Access Compliance Report

Public Rights-of-Way

(Curb Ramps)

Intersection ID: 20278	Main Street: ARCHDALE_DR	Cross Street: MONTPELIER_RD	Location:	W
ADA ID: 6150BD09B509	Ramp Type: PerpDiag	Initial Pass/Fail: Fail	Overall Compliance: No	Severity Score: 22.5
Codes/Mitigation Info/Possible Solution		Field Measurements/Component Compliance

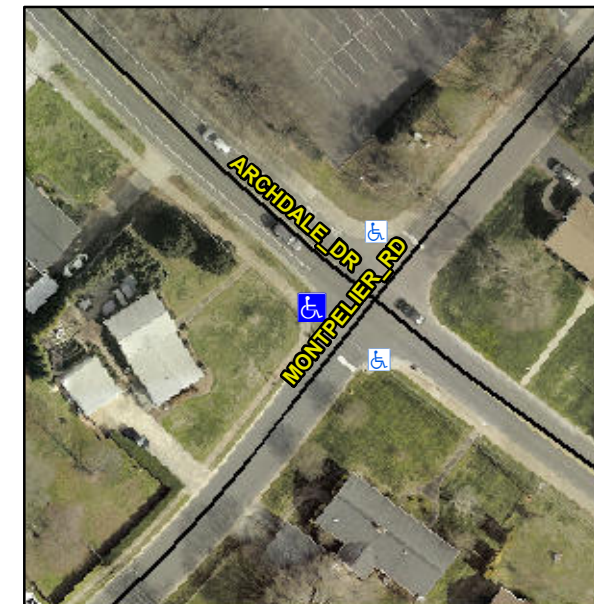
Not Found, R304.5.1, R304.2.2, R304.5.3

Compliance	Description	Data	Compliance	Description	Data
N/A	Ramp Length (in)	72.0	No	Ramp Slope (%)	8.6
No	Ramp Width (in)	45.0	No	Ramp XSlope (%)	3.8
N/A	Flare Type LT	N/A	N/A	Flare Type RT	N/A
N/A	Flare Slope LT (%)	N/A	N/A	Flare Slope RT (%)	N/A
N/A	Flare Traversable LT?	N/A	N/A	Flare Traversable RT?	N/A
N/A	Landing Length (in)	N/A	N/A	DWS Provided?	N/A
N/A	Landing Width (in)	N/A	N/A	DWS Contrast?	N/A
N/A	Landing Slope (%)	N/A	N/A	DWS Length (in)	N/A
N/A	Landing X Slope (%)	N/A	N/A	DWS Full Width?	N/A
N/A	Landing Curb? (Y/N)	N/A	N/A	DWS Offset (in)	N/A
N/A	Shared Landing?	N/A			
N/A	Gutter Ponding?	N/A	N/A	Gutter Slope (%)	N/A
N/A	Gutter Lip Ht (in)	N/A	N/A	Gutter X Slope (%)	N/A
N/A	Painted X Walk1?	No	N/A	Painted X Walk2?	No
	X Walk 1 Direction	To SE		X Walk 2 Direction	To NE
N/A	X Walk 1 Width (in)	N/A	N/A	X Walk 2 Width (in)	N/A
	X Walk 1 Slope (%)	2.1		X Walk 2 Slope (%)	3.0
	X Walk 1 X Slope (%)	0.5		X Walk 2 X Slope (%)	1.4

Remove & Replace Curb Ramp With Two New Directional Ramps or Equivalent.
